1. Claim of Priority to '951 Application

2. Figure 2 Drawing

EXHIBIT B

Patent Application for: FULL WRAPPING DISPOSABLE REFASTABLE AND ADJUSTABLE PANT
Inventor(s): Datta et al.
Attorney Docket No.: 659-829 & Kimberly Clark Ref. No. 14-104-1

Fig. 1A

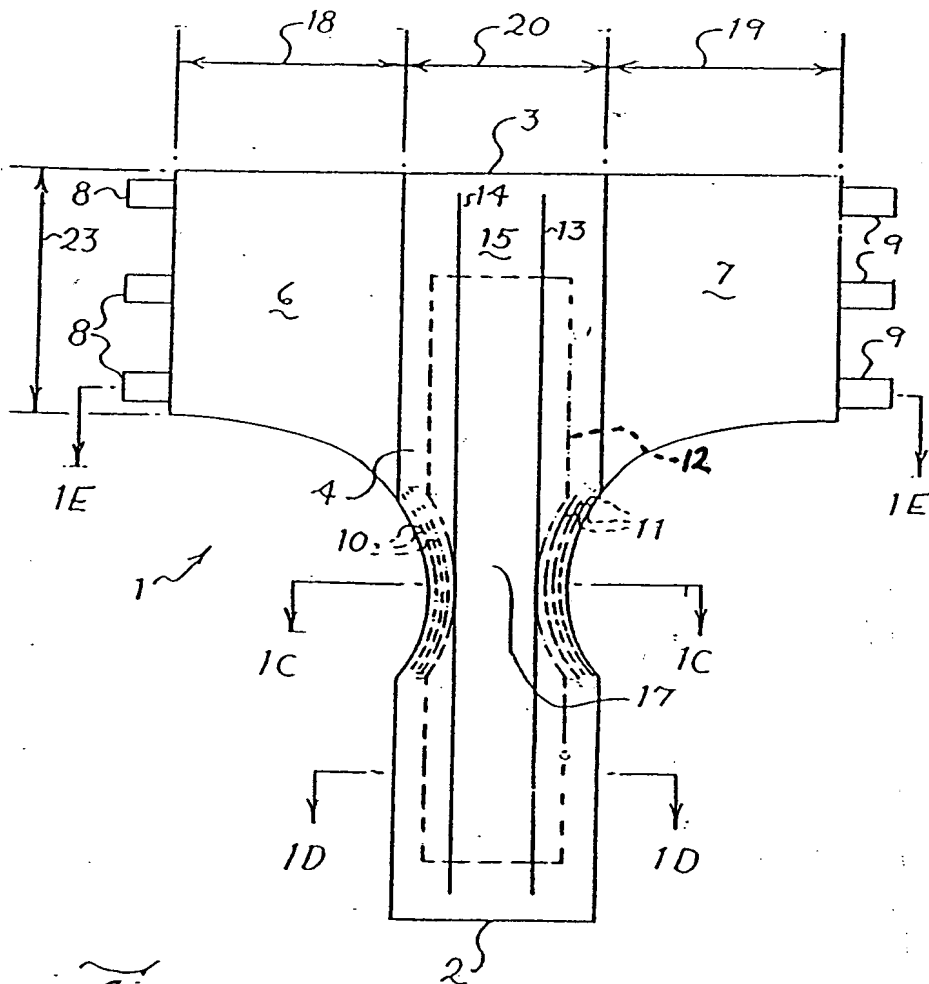
The drawings are objected to because in Figure 1A, the top layer of the chassis designated 15 and 12 and the absorbent pad is not designated 12. Element 5 in Figures 1B and Figure 2 are not consistent. Element 1 shown in Figures 1A and 1B and that in Figure 3 are inconsistent. A proposed drawing correction or corrected drawings are required in reply to the Office Action to avoid abandonment of the application.

Applicants have amended Figure 1 so that 12 now appear with dashed lines to indicate that it is underneath 15. Figure 2 and the corresponding disclosure in the specification have been amended to change the designation for the front panel from 5 to 51. In figure 5 the outer member serves as the fastening panel. Support for this embodiment is expressly found at page 4, line 2, and in the drawing of figure 2, as originally submitted. (Designation 51 is not used in any other figure). Plaintiffs have amended Figure 3 and the corresponding text in the specification to change the designation from 1 to 111. (Designation 111 is not used in any other figure). Thus, Applicants have overcome the objections to the drawings set forth in Item 4.

Figure 2 Drawing (Amended 9-30-02)

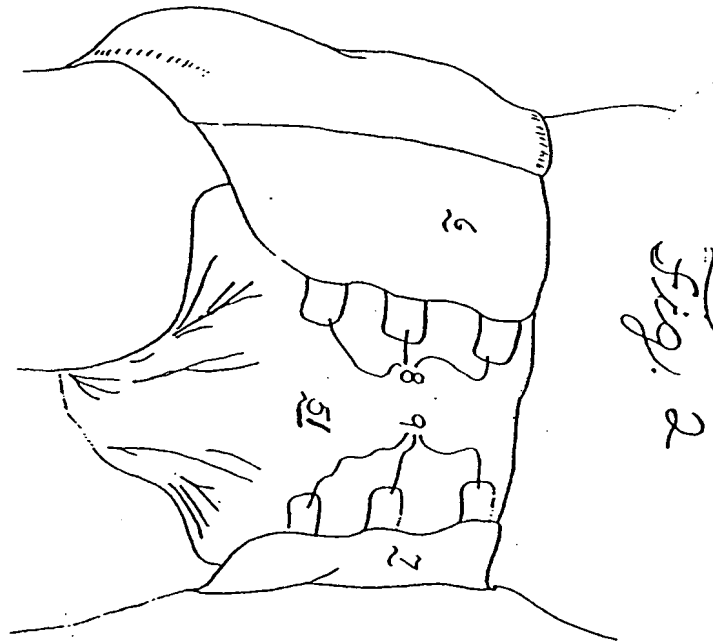
If Applicants maintains the request to have Figure 2 approved as proposed 9-30-02 the nature of the invention shown in Figure 2 would be much clearer if on page 4, line 2, after "panel", -- , see Figure 2 – could be inserted.

The proposed drawing correction and/or the proposed substitute sheets of drawings, filed on 9-30-02 have been approved in part (Figures 1A and 3 only). A proper drawing correction or corrected drawings are required in reply to the Office action to avoid abandonment of the application. The correction to the drawings will not be held in abeyance. . . **The drawing change proposed for Figure 2 was not approved because such gave two different designations to the same front end fastener.** See discussion infra.

The drawings are objected to because element 5 in Figures 1B and 2 are not consistent, i.e. a square like that shown in Figure 1B should be labeled 5 in Figure 2. A proposed drawing correction or corrected drawings are required in reply to the Office action to avoid abandonment of the application. The objection to the drawings will not be held in abeyance.

With regard to Item 3 and Item 5, second full paragraph, the understanding of the invention is based on the disclosure of the invention in the specification. Applicants have not described the front fastening panel in Figure 2 as being a different embodiment nor pointed out such at the disclosure on page 4, line 2, which line is a description of the fastener 5. The Examiner's objection to the proposed Figure 2 in paragraph 2 of the FINAL, the objection to the originally filed drawings in paragraph 3 of the FINAL and the objection to the original specification as amended 9-30-02 in paragraph 4, item 2), of the FINAL are based on such description. If Applicant maintains the request to have Figure 2 approved as proposed 9-30-02 the nature of the invention shown in Figure 2 would be much clearer if on page 4, line 2, after "panel", --, see 51 in Figure 2 -- could be inserted.

The Examiner's parting comment is ambiguous and places a cloud over Applicants' case. There is no ambiguity in the specification and Applicants request the approval of Figure 2 (as submitted on 9-30-02), without any changes to the specification. Moreover, the Examiner's gratuitous comment that "the nature of the invention shown in Figure 2 would be much clearer" is totally improper. This comment has no basis in fact or law. At

The Examiner's objection to the amendment to Figure 2 shows a fundamental misunderstanding of Applicants' invention, the disclosure in Applicants' specification and Item 4 of Applicants' September 30, 2002 Response. A separate patch of material to serve as a landing member is not part of the embodiment shown in Figure 2. Thus the closure mechanism of Figure 2 works without the need for a separate patch of material, i.e. the patch of material shown as number 5 in Figure 1D is not needed nor intended to be in Figure 2. Moreover, support for the drawing of Figure 2, without a separate patch of material, is expressly found at page 4, line 2 of the specification, which provides: "[a]lternatively, an outer member may serve as the fastening panel." Thus, contrary to the Examiner's assertion, a drawing of Figure 2 is not required or intended to have a "separate square like that shown in Figure 1B." Such a separate square is not needed for the closure mechanism to function. . . Accordingly, amended Figure 2, which does not show a separate material, is correct as drawn.
